ORDINARY AGENDA

Tuesday 13 April 2021

Applicant	BVZ Designs
Owner	M Rezaie, R Rezaie, R Rezaie
Property	11 Sturgis Place PROSPECT VALE (CT:175463/16)
Zoning	General Residential Zone
Discretions	10.4.4 Sunlight and overshadowing for all dwellings E6.7.2 Design and Layout of Car Parking
Existing Land Use	Vacant Land
Number of Representations	Six (6)
Decision Due	14 April 2021
Planning Scheme:	<p>Meander Valley Interim Planning Scheme 2013 (the Planning Scheme).</p> <p>Note:</p> <p>Interim Planning Directive No. 4 became operational on 22 February 2021. Applications lodged on or after this date are subject to assessment against the provisions in the directive. The application was lodged and became valid on 29 January 2021, therefore the provisions in the Interim Planning Directive No. 4 are not applicable to the proposal.</p> <p>Meander Valley Council has received the Notice of Decision from the Tasmanian Planning Commission for the Draft Meander Valley Local Provisions</p>

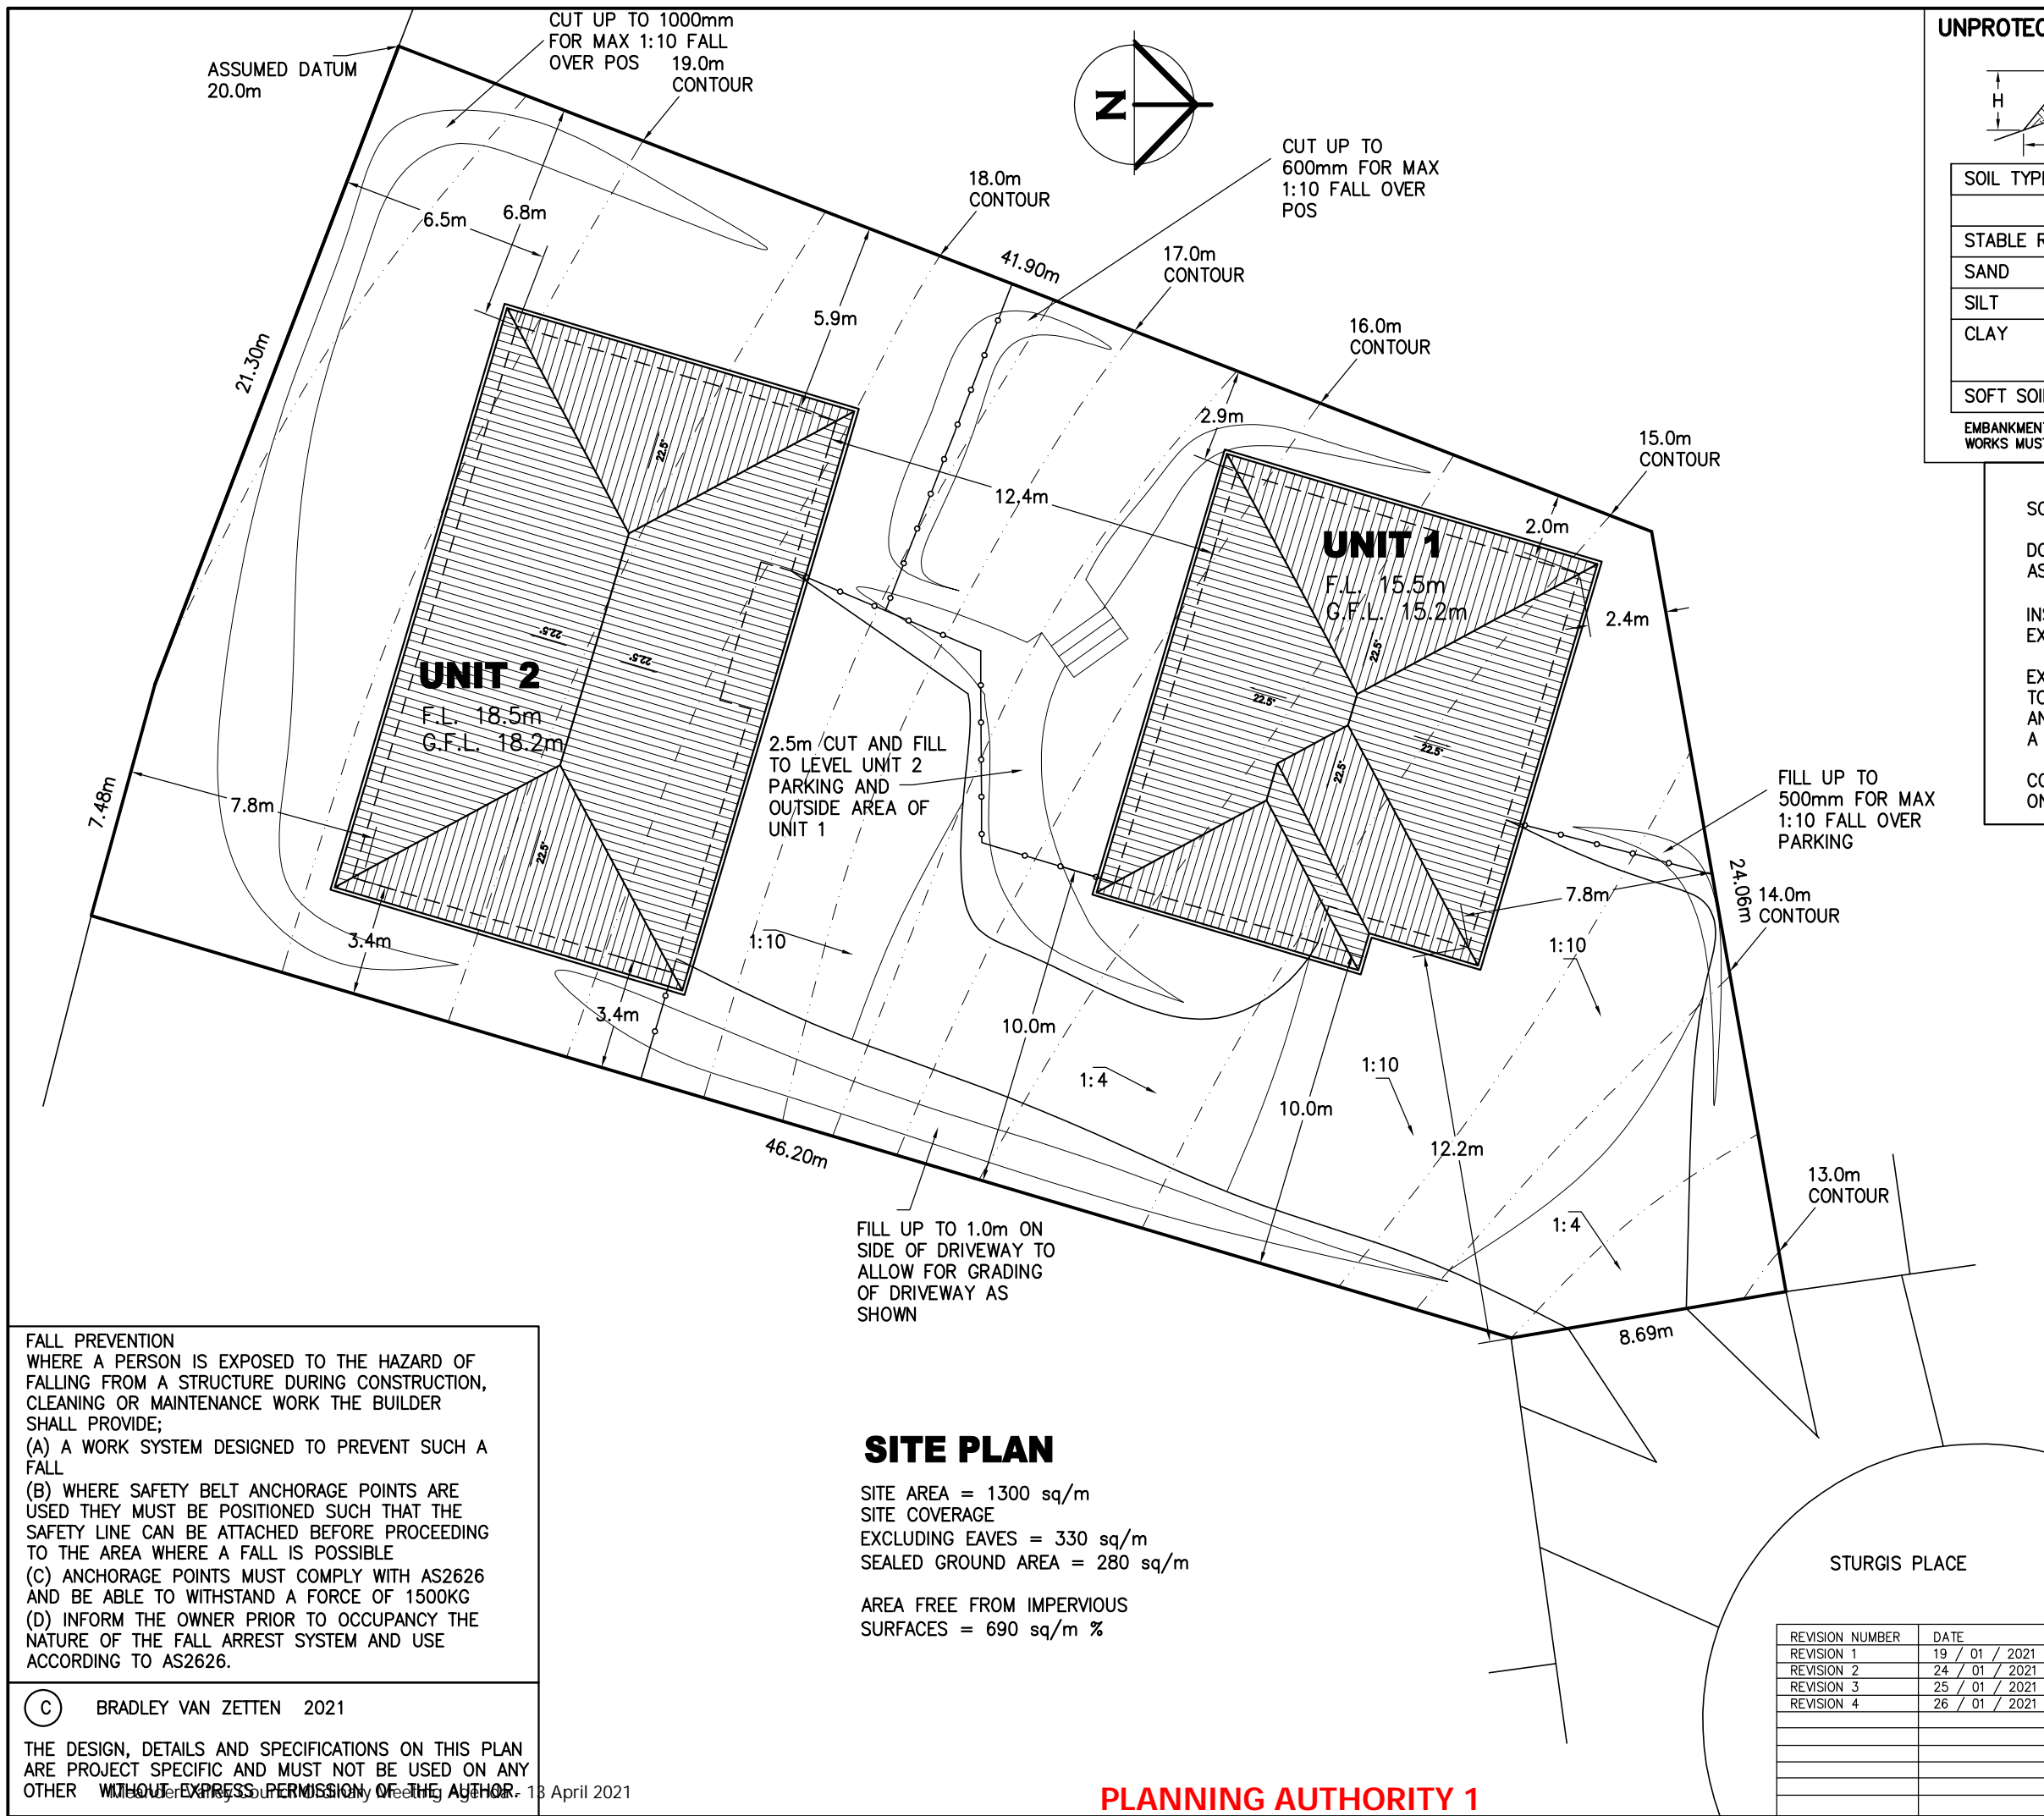
Concern – Stormwater pits show on drawing REZ0121-4/10 do not seem to correlate with surface levels and falls shown on drawing REZ0121-2/10. Based on the levels as discussed above and drawing REZ0121-2/10, the parking spaces and driveways must be shaped north, north-east toward our shared boundary. There is no method of collecting (stormwater pits) or directing (eg. Kerb and channel) the stormwater being directed and concentrated toward the shared boundary.

Concern – Landscaping: While the buildings are set from the boundary, where the driveway crossover is (dimensioned 8.69m on drawing REZ0121-2/10) the view from the street will be almost entirely of concrete driveway. All other properties, including those with multiple dwellings, in this street and the greater area have nature strips to soften the visual impact as viewed from the street. Acknowledgment is given of the attempts made by the inclusion of narrow landscaping strips each side of the driveway, but the primary view will be one of 160m² of concrete which is not in keeping with the area.

Concern - The visitor parking space, as noted on drawing REZ0121-5/10 is shown on drawing REZ0121-2/10 with the pavement extending almost to the north boundary (dimensioned 24.06m). This corner of pavement overlaps a shape identified as 500mm maximum fill 1:10 fall across the parking space. The adjacent garage floor is noted as 15.2m and the parking space pavement is 7.4m wide. Interpolating the contour lines shown on the drawing, this pavement will be between 300mm and 1m above natural surface level. The exact levels are difficult to determine as the advertised plans do not provide

Figure 2: Diagram of recommended modifications over submitted subdivision plan.

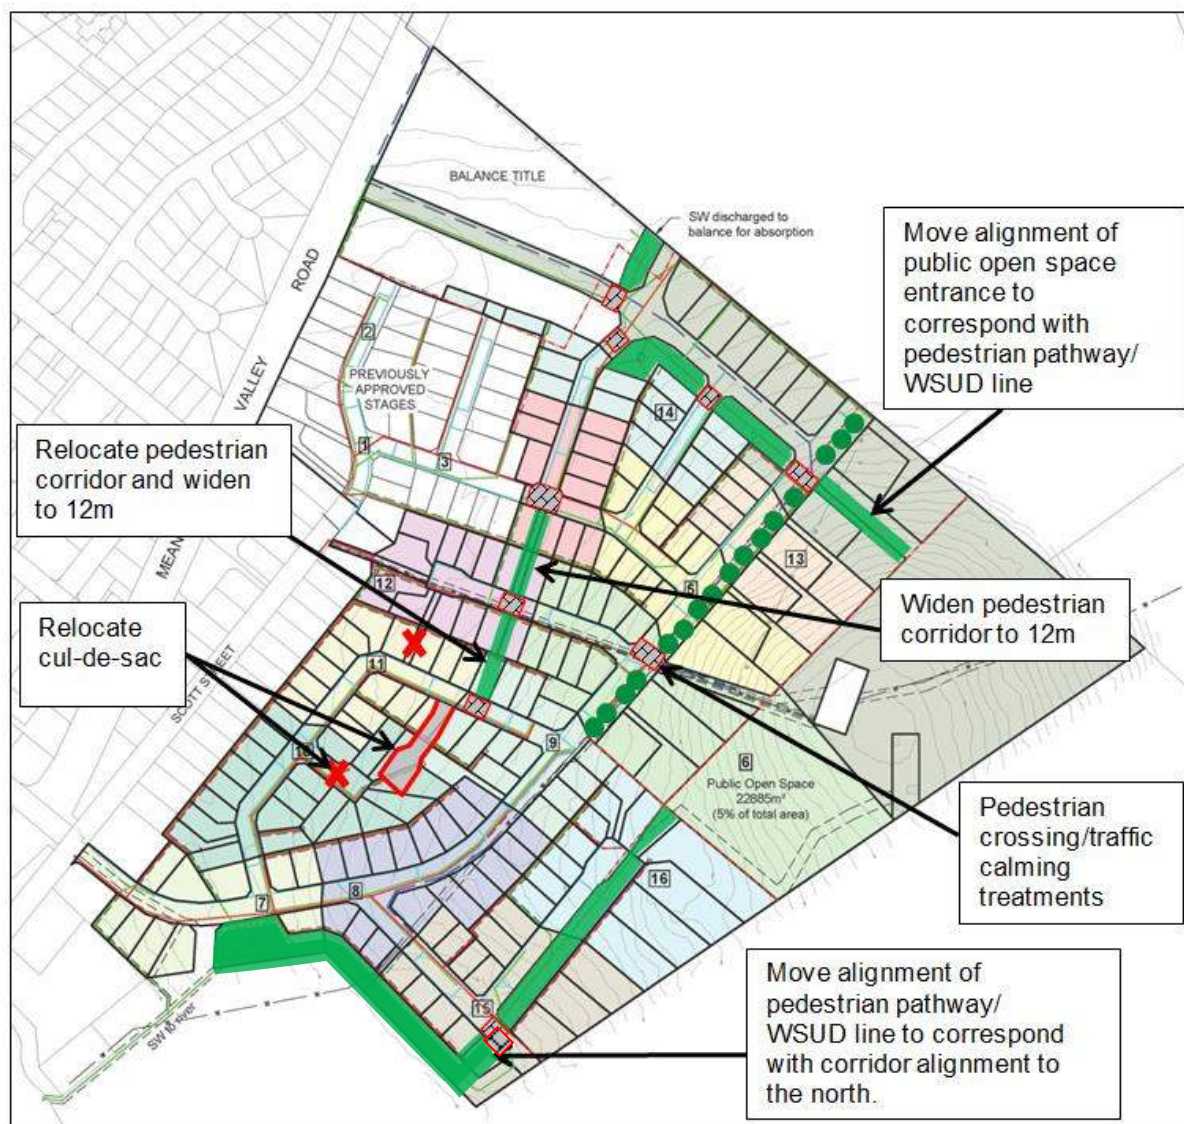
These changes are indicated in Figure 2.

In addition to improvements in pedestrian pathway alignment, the small cul-de-sac in Stage 10 should be re-configured and re-aligned as it has too high a concentration of lots in the turning head and can provide for a more direct connection to the pedestrian corridor. This is discussed below and indicated in Figure 2.

Figure 4: Key WSUD Stormwater line showing inputs from stages 13 and 14.

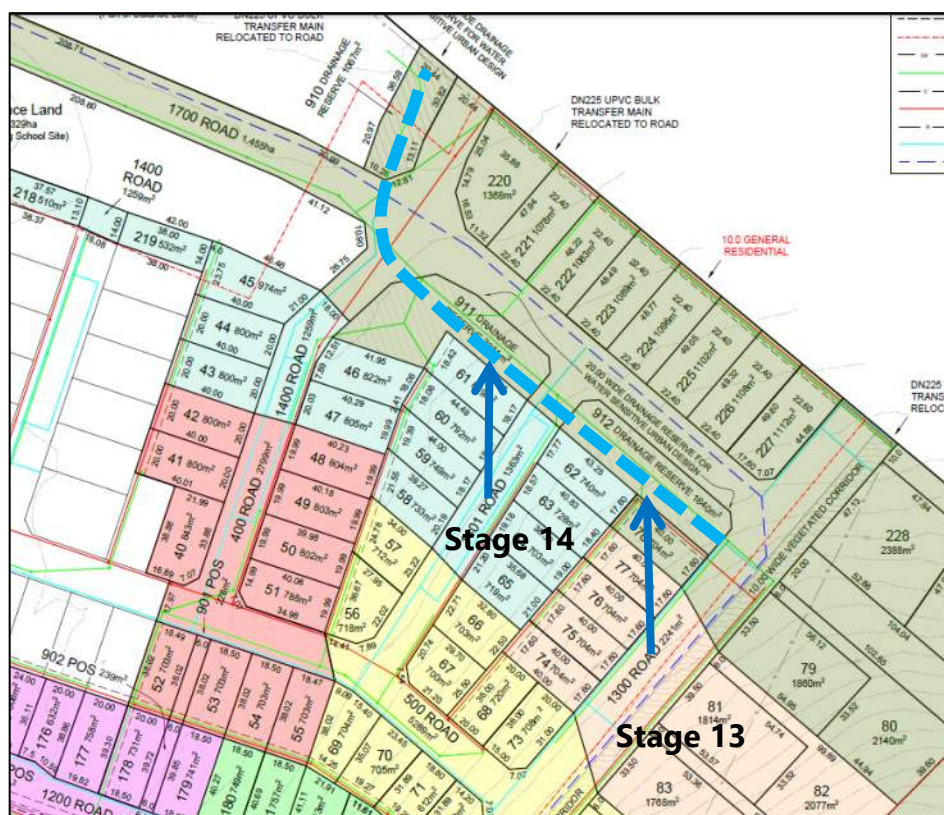
Figure 4 below, extracted from the application document, indicates that stormwater from stages 13 and 14 discharge through the key WSUD stormwater provided later in the development through Stage 17. A substantive amount of stormwater catchment from roads and lot drainage will need to be discharged before it is proposed to construct this part of the system. Temporary drainage through an important part of the system is not considered an appropriate response and it is recommended that condition be included to ensure that the WSUD system within

Lots 911 and 912 is established when stages 13 and 14 are constructed, including the detention basin.
